Access Compliance Report

Public Rights-of-Way

(Curb Ramps)

Intersection ID: N/A	Main Street: INVERNESS_BAY_RD	Cross Street: ELGIN_MOOR_RD	Location: NW
ADA ID: 2CF463C0D6DE	Ramp Type: Perp	Initial Pass/Fail: Fail	Overall Compliance: No
		Severity Score: 25

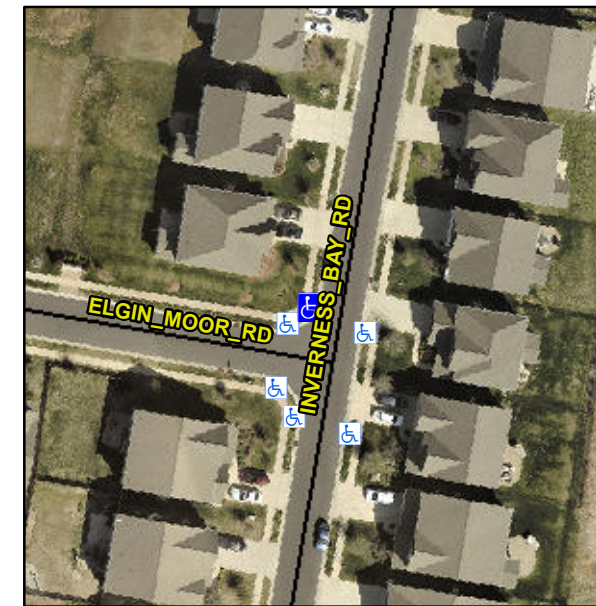
Not Found, R304.2.2, R304.5.3

Compliance	Description	Data	Compliance	Description	Data
N/A	Ramp Length (in)	45.0	No	Ramp Slope (%)	10.5
Yes	Ramp Width (in)	48.0	No	Ramp XSlope (%)	5.1
N/A	Flare Type LT	N/A	N/A	Flare Type RT	N/A
N/A	Flare Slope LT (%)	N/A	N/A	Flare Slope RT (%)	N/A
N/A	Flare Traversable LT?	N/A	N/A	Flare Traversable RT?	N/A
N/A	Landing Length (in)	N/A	N/A	DWS Provided?	N/A
N/A	Landing Width (in)	N/A	N/A	DWS Contrast?	N/A
N/A	Landing Slope (%)	N/A	N/A	DWS Length (in)	N/A
N/A	Landing X Slope (%)	N/A	N/A	DWS Full Width?	N/A
N/A	Landing Curb? (Y/N)	N/A	N/A	DWS Offset (in)	N/A
N/A	Shared Landing?	N/A			
N/A	Gutter Ponding?	N/A	N/A	Gutter Slope (%)	N/A
N/A	Gutter Lip Ht (in)	1.0	N/A	Gutter X Slope (%)	N/A
N/A	Painted X Walk1?	No	N/A	Painted X Walk2?	N/A
	X Walk 1 Direction	To SE		X Walk 2 Direction	N/A
N/A	X Walk 1 Width (in)	N/A	N/A	X Walk 2 Width (in)	N/A
	X Walk 1 Slope (%)	3.0		X Walk 2 Slope (%)	N/A
	X Walk 1 X Slope (%)	3.2		X Walk 2 X Slope (%)	N/A

Remove & Replace Entire Ramp.
